APPLICATION FOR A CERTIFICATE OF APPROPRIATENESS – STAFF REPORT

082-18-CA 513 N BLOODWORTH STREET

Nature of Project: Demolish existing 2-car garage and shed; construct 2-car garage; replace concrete driveway with brick driving strips; install brick patio; remove and replace tree DRAC: An application was reviewed by the Design Review Advisory Committee at its May 2, 2018, meeting. Members in attendance were Curtis Kasefang, and David Maurer; also present were staff members Melissa Robb and Collette Kinane, and applicants Thomas Harrill and Valentina Zhukova-Harrill.

513 N Bloodworth St - New Driveway Side Elevation of Garage Scale - 3/32" = 1'-0"

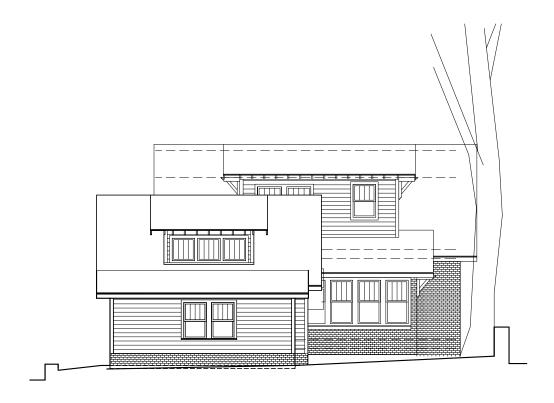
- 7* The height of the house is 28′-5″ at the roof ridge, while the height of the proposed garage will be 18′-10″ from grade. The drawing labeled New Driveway Side Elevation of Garage illustrates the change in grade from the ridge of the house to the rear of the proposed new garage.
